Harrell Design Group, PC AMENDMENT 02 July 11, 2024

RENOVATE SPACE FOR LOGISTICS (B-1) VA PROJECT #564-24-104

Veterans' Healthcare System of the Ozarks

HDG Project Number: 19022-A

21 JUNE 2024

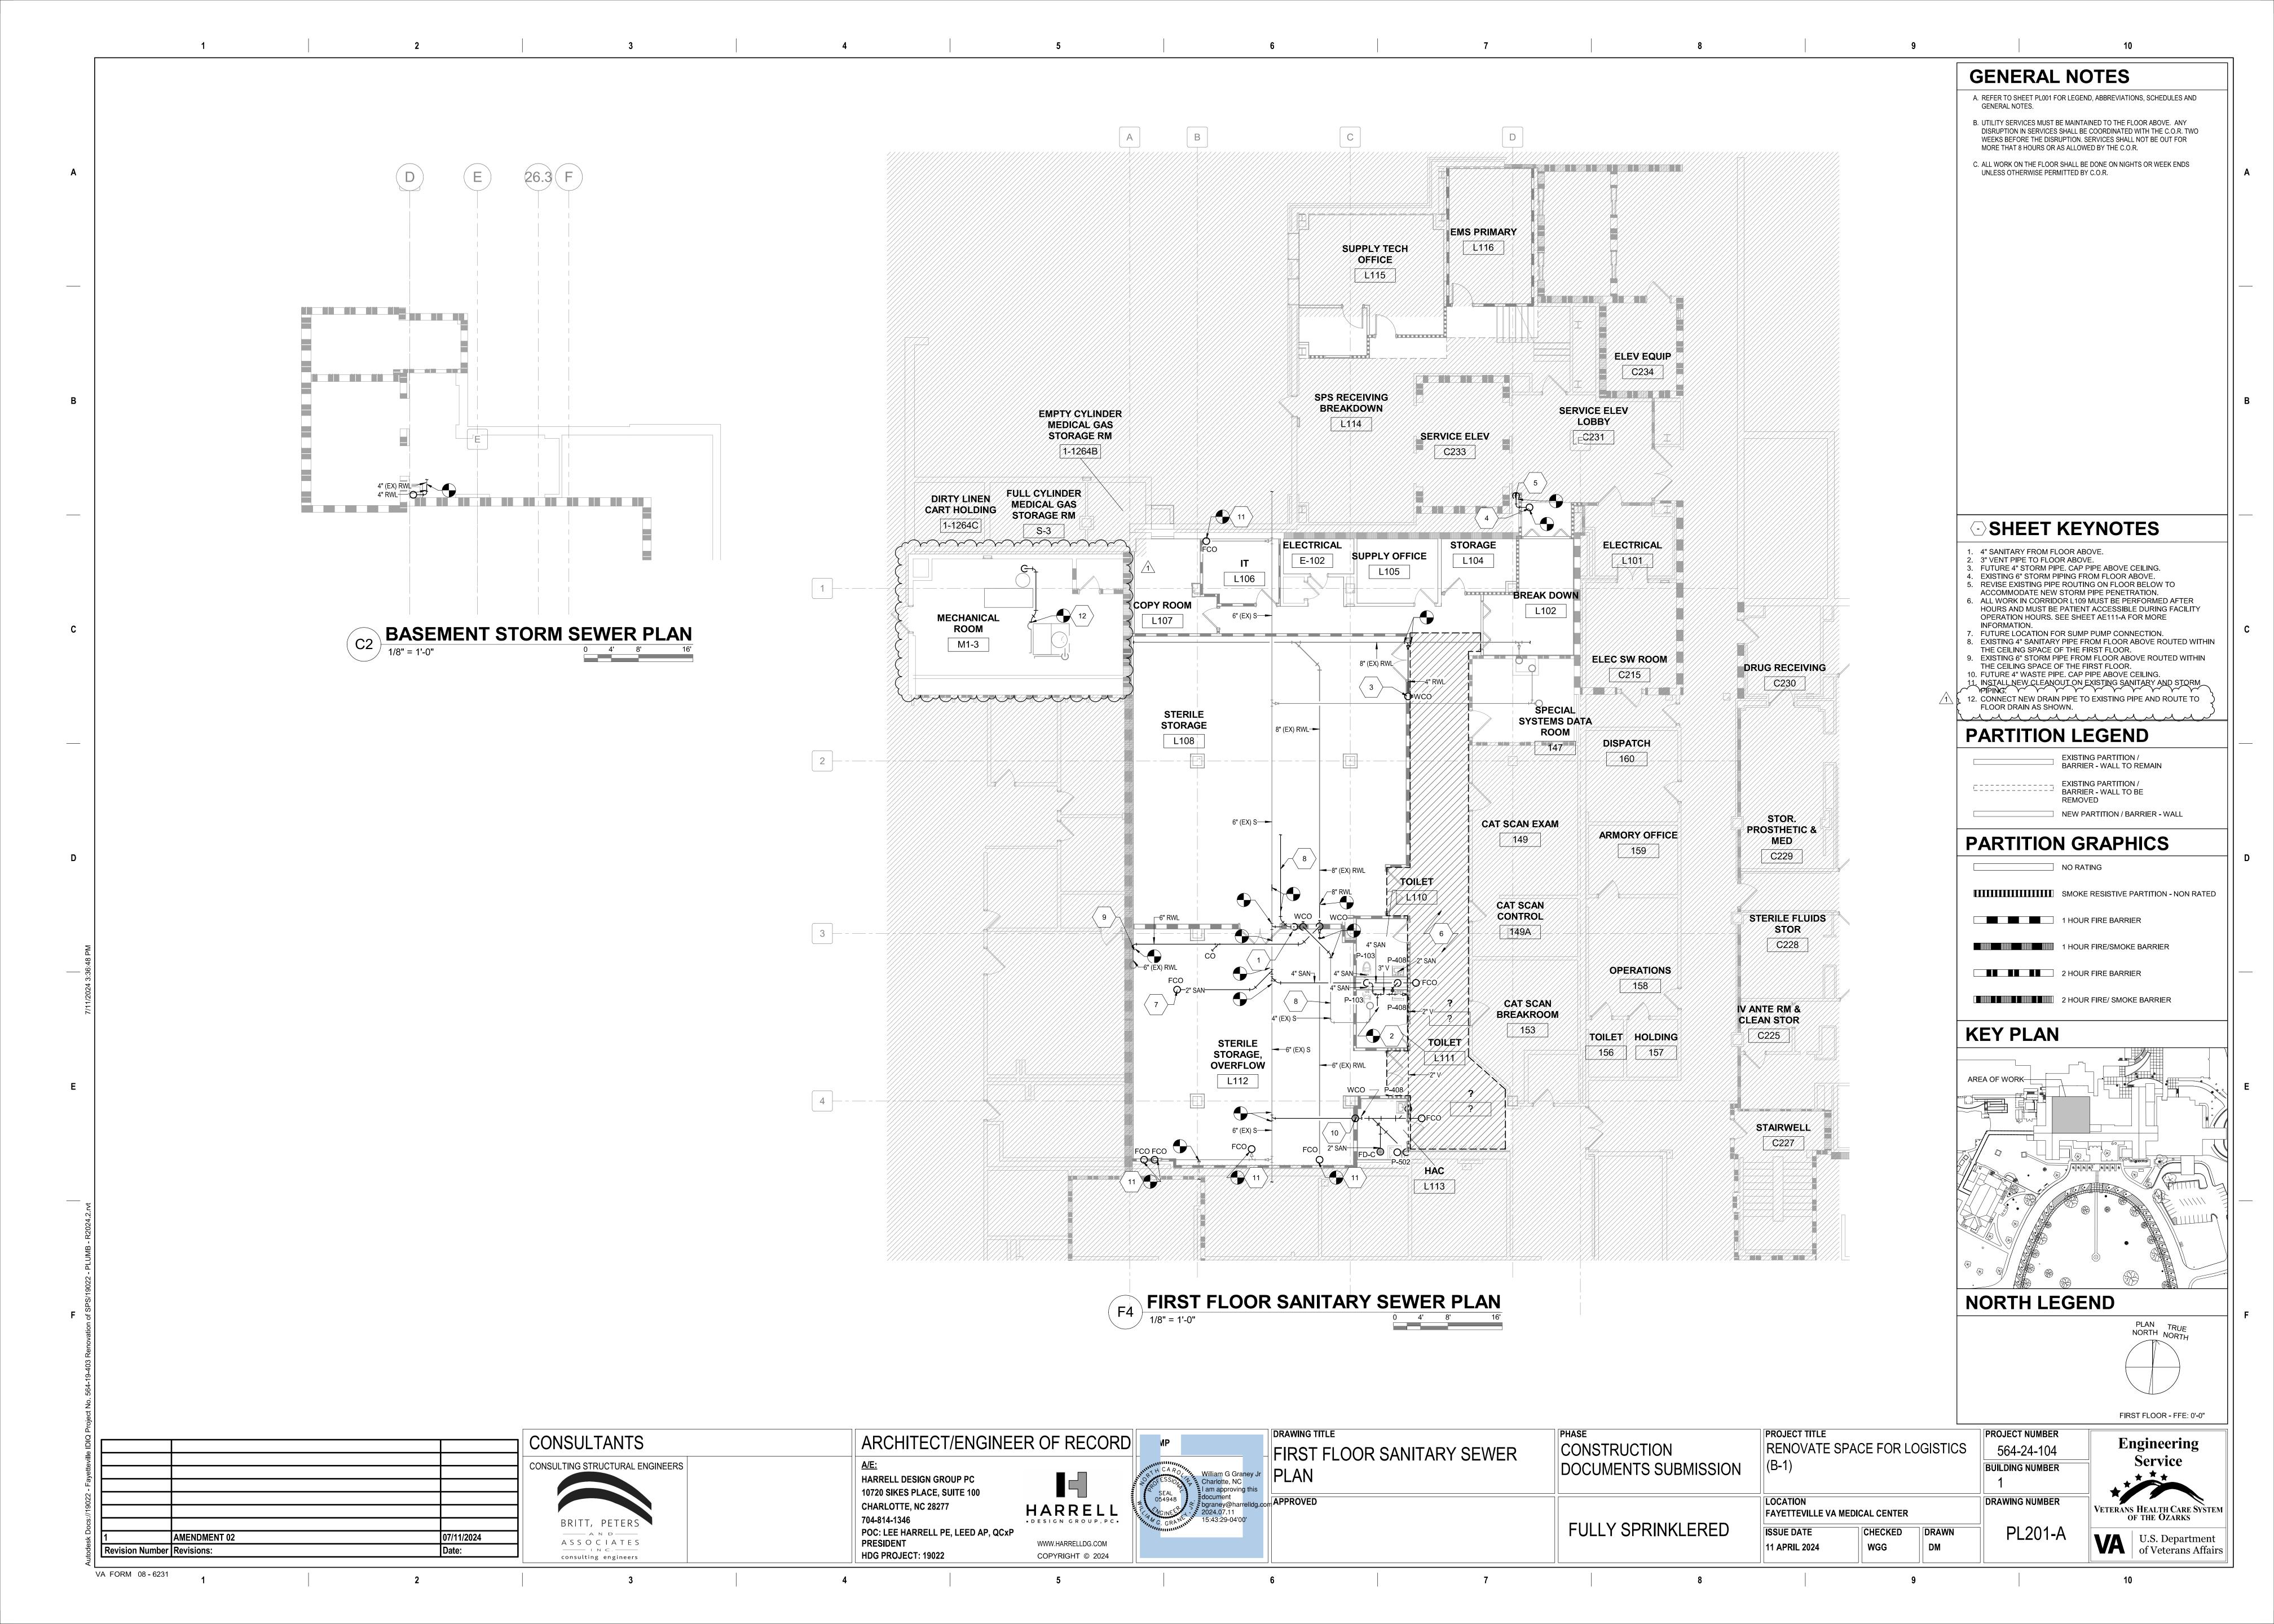
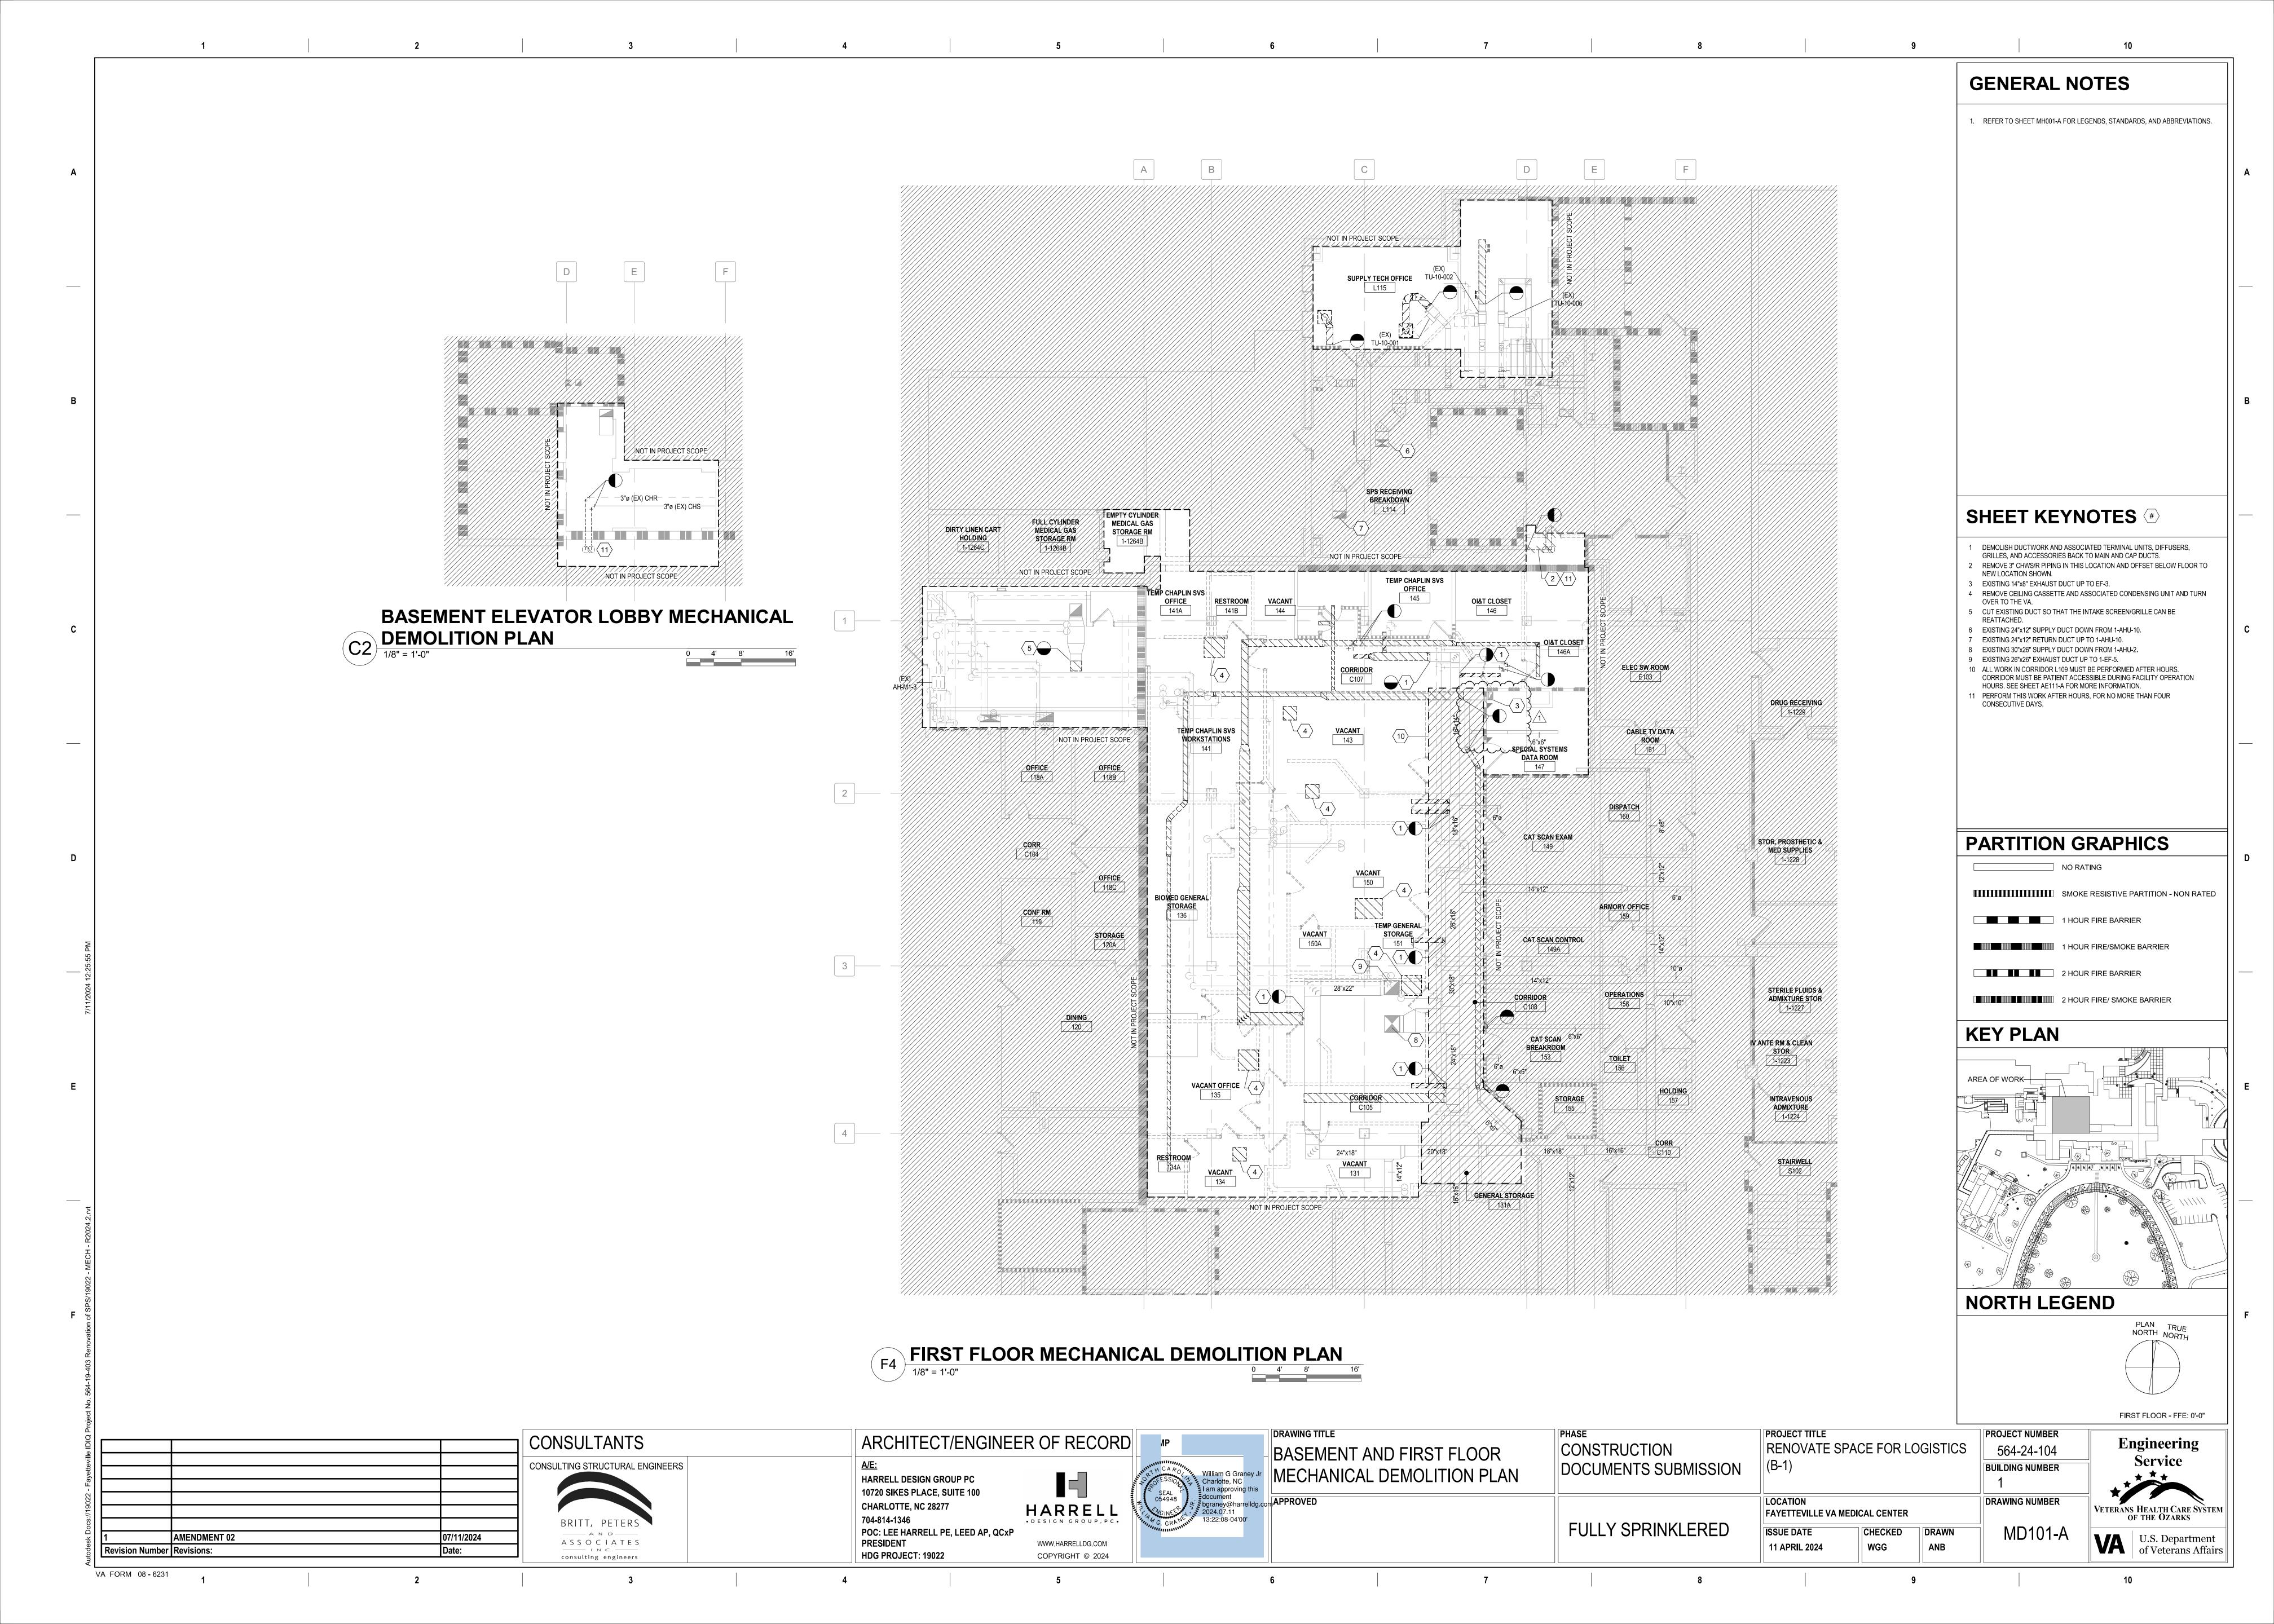
- i. The Signage Schedule was updated to reflect the correct room names, room numbers, and quantities of all signage.
- ii. Corridor L109 was added to the Finish Schedule.
